Title of Change:	Silicon Etch in Post Fab to replace Mechanical First Cut in Assembly
Proposed first ship date:	1 December 2019
Contact information:	Contact your local ON Semiconductor Sales Office or <eben.lim@onsemi.com>
Samples:	Contact your local ON Semiconductor Sales Office or <PCN.samples@onsemi.com> Sample requests are to be submitted no later than 30 days from the date of first notification, Initial PCN or Final PCN, for this change. Samples delivery timing will be subject to request date, sample quantity and special customer packing/label requirements.
Additional Reliability Data:	Contact your local ON Semiconductor Sales Office or <Nicky.Siu@onsemi.com>
Type of notification:	This is a Final Product/Process Change Notification (FPCN) sent to customers. FPCNs are issued 90 days prior to implementation of the change. ON Semiconductor will consider this change accepted, unless an inquiry is made in writing within 30 days of delivery of this notice. To do so, contact <PCN.Support@onsemi.com>

This Final Product Change Notification (FPCN) is notifying customers regarding the addition of Silicon etch process in Niigata(Japan) to replace mechanical first cut in Seremban(Malaysia

Process Flow before and after Implementation**Before****After**

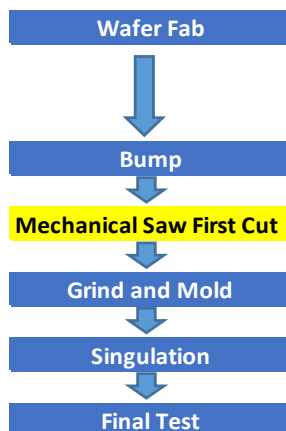
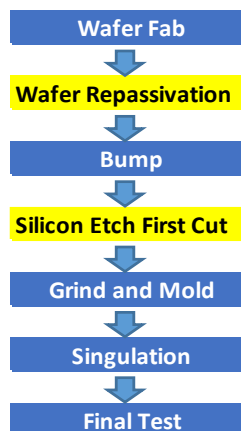
Before Change Description	After Change Description
Wafer Repassivation	None	WPR-5100 (WLP Insulation film)
